1. Replace 33.2.11.1.2

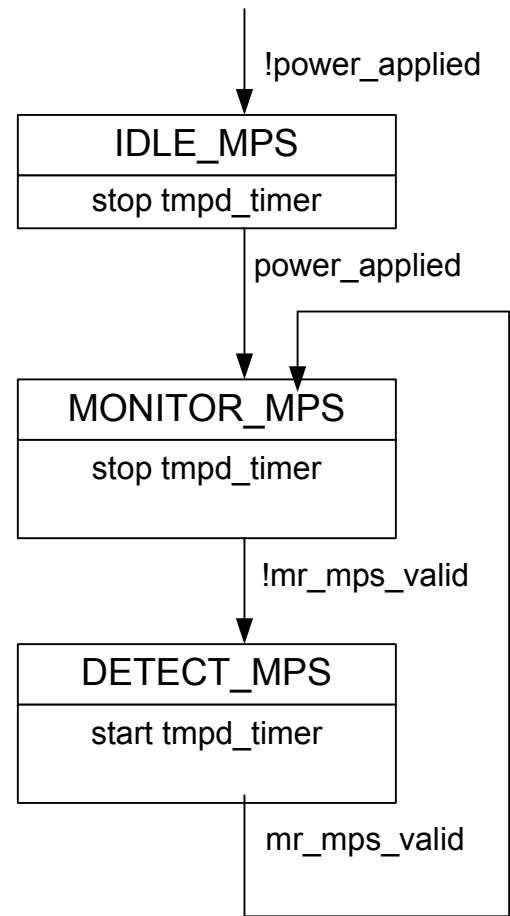
According to the state diagram in Figure 33-1.

A PSE shall consider the DC MPS to be TRUE, and PD present, if it detects that IPort is greater than or equal to IHLD max for at least TMPS min every TMPS min + TMPDO max. A pulsed DC MPS current allows PDs to decrease their minimum average power.

A PSE shall consider the DC MPS to be FALSE, and PD absent, if IPort is less than or equal to IHLD min for a duration greater than or equal to TMPDO min.

The specifications for TMPS in Table 33-11 applies only to the DC MPS component
